Product Change Notice (PCN)

Subject: Notice of change in 14x14mm 64pin LQFP Tape & reel Packing Components for R8C/36x

Publication Date: 4/23/2024

Difference of specification's detail (1)

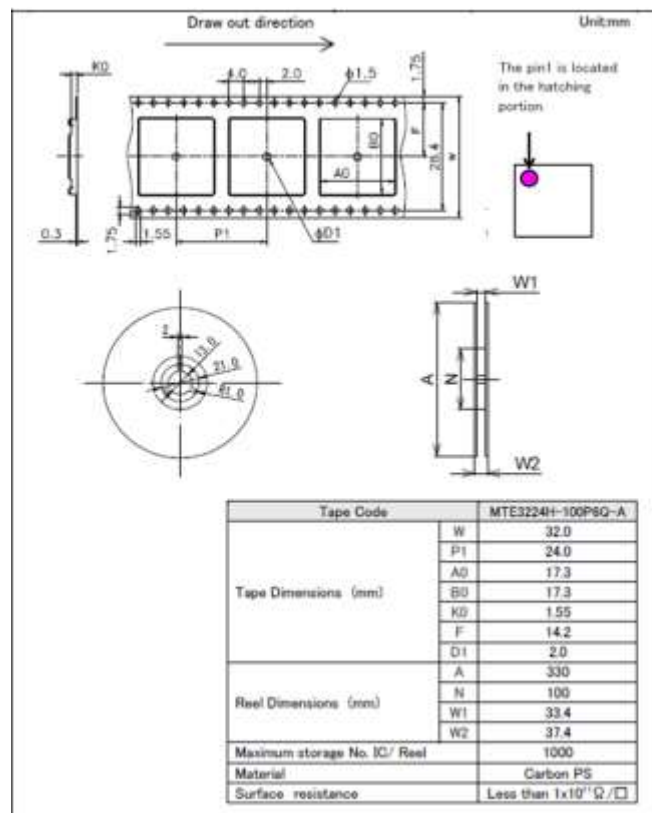
Comparison of tape & reel material details: 14x14mm LQFP Tape & Reel packing

Packing material	Item	Before	After
Emboss tape	Taping code	MTE3224H-100P6Q-A	E2424Q14RA
	Sprocket hole	Both side	One side
	Tape width	32mm	24mm
	Tape thickness	0.3mm	0.3mm
	Cavity size	17.3x17.3	16.5x16.5
	Cavity depth	1.55mm	1.4mm
	Distance between cavity centers	24mm	24mm
	Material	PS	PS
Reel	Reel diameter	330mm	330mm
	Core diameter	100mm	100mm
	Reel width	For 32-mm tape width	For 24-mm tape width

Difference of specification's detail (2)

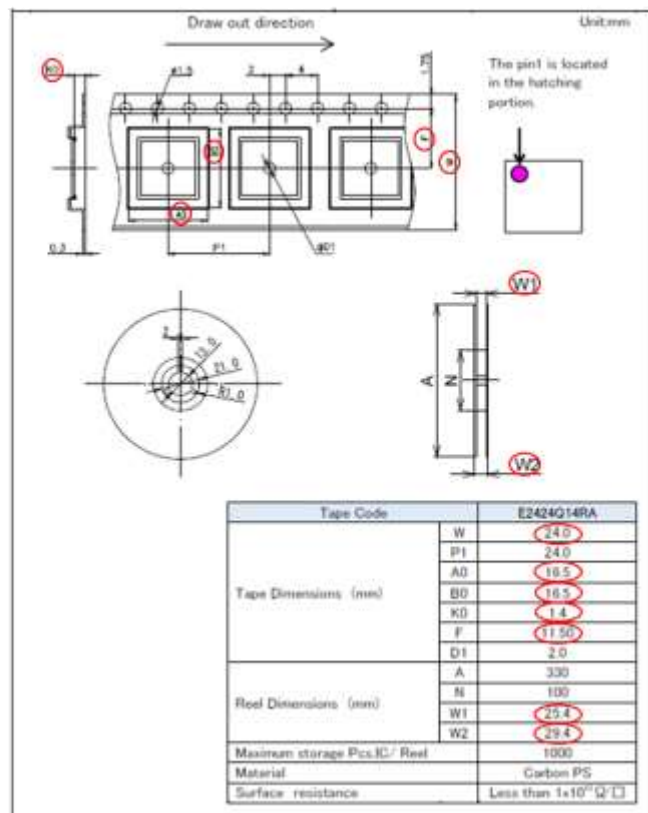
Comparison of tape & reel dimension: 14mmx14mm LQFP Tape & Reel packing

Before (W:32mm)

After (W:24mm)
